# **MEMORANDUM**

RE: Updated site plan with detailed landscaping for variance application by James Talago (PL 20-120)

JAMES PATRICK DEVELOPMENT JEFFERSON STREET 5 PLEX DULUTH, MINNESOTA

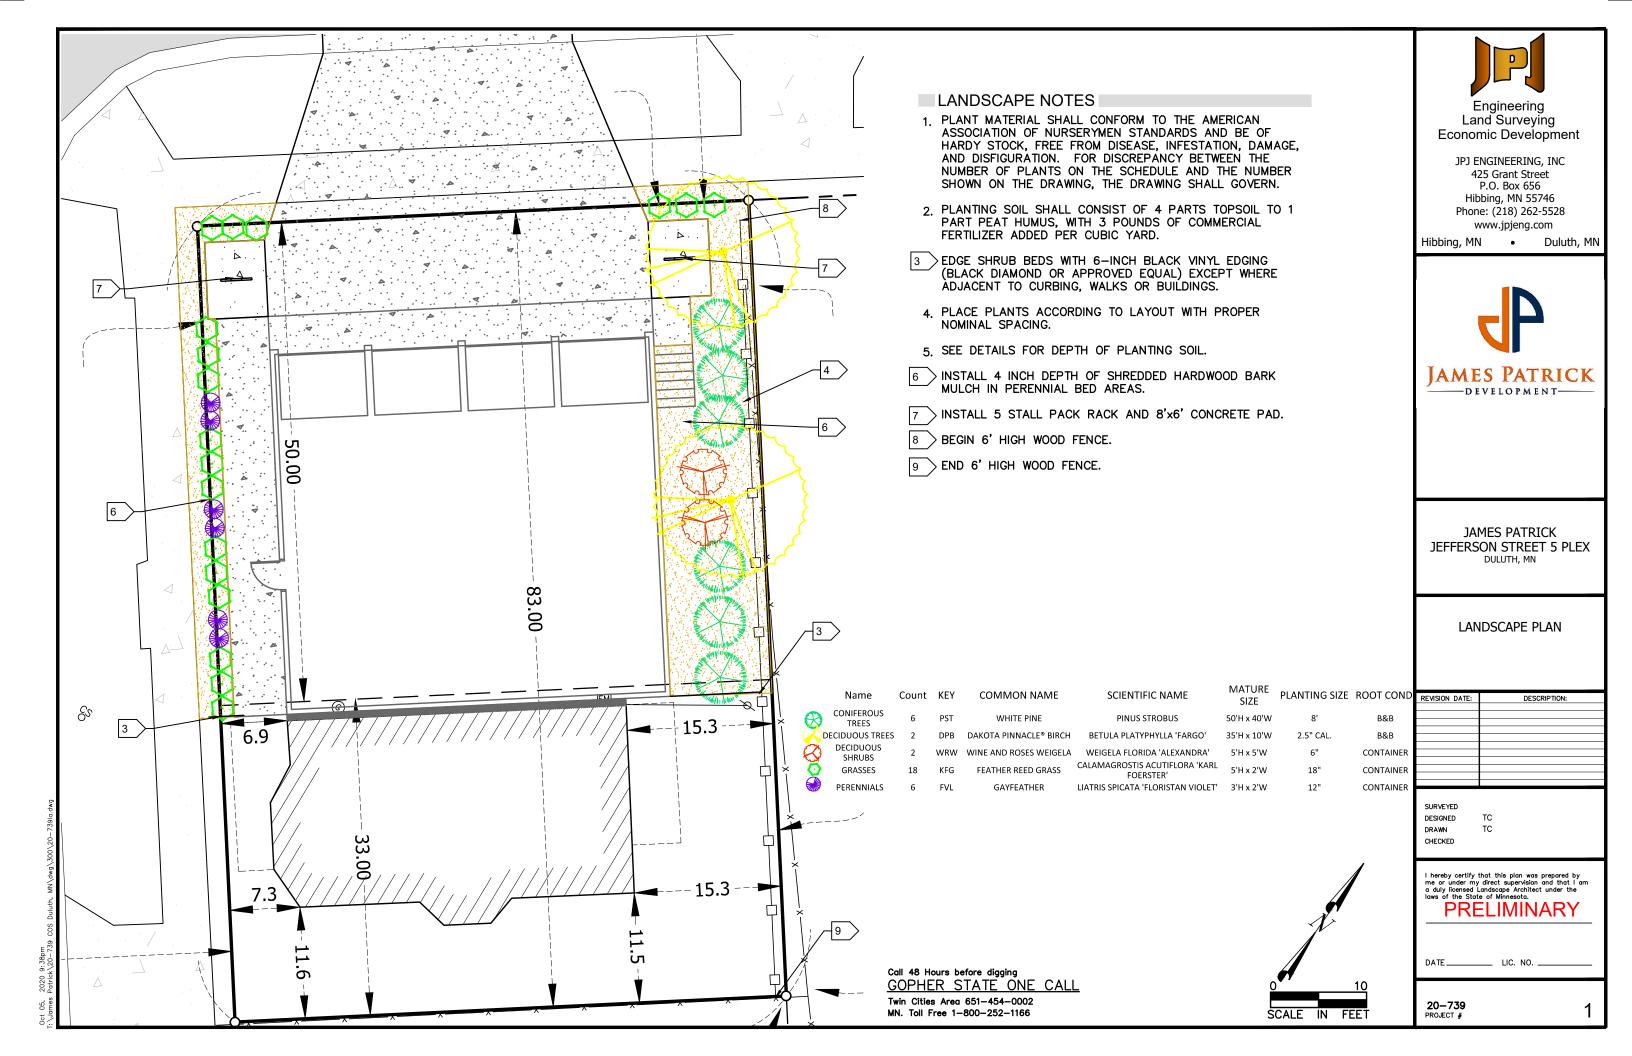
The applicant, James Talago, has submitted an updated landscaping plan showing more detail of the buffer between the proposed structure and the neighboring property. This landscaping is often a requirement for variances that reduce setbacks. The updated landscape plan also shows two bike racks located on the property. The fence indicated on the updated plan will require a separate fence permit.
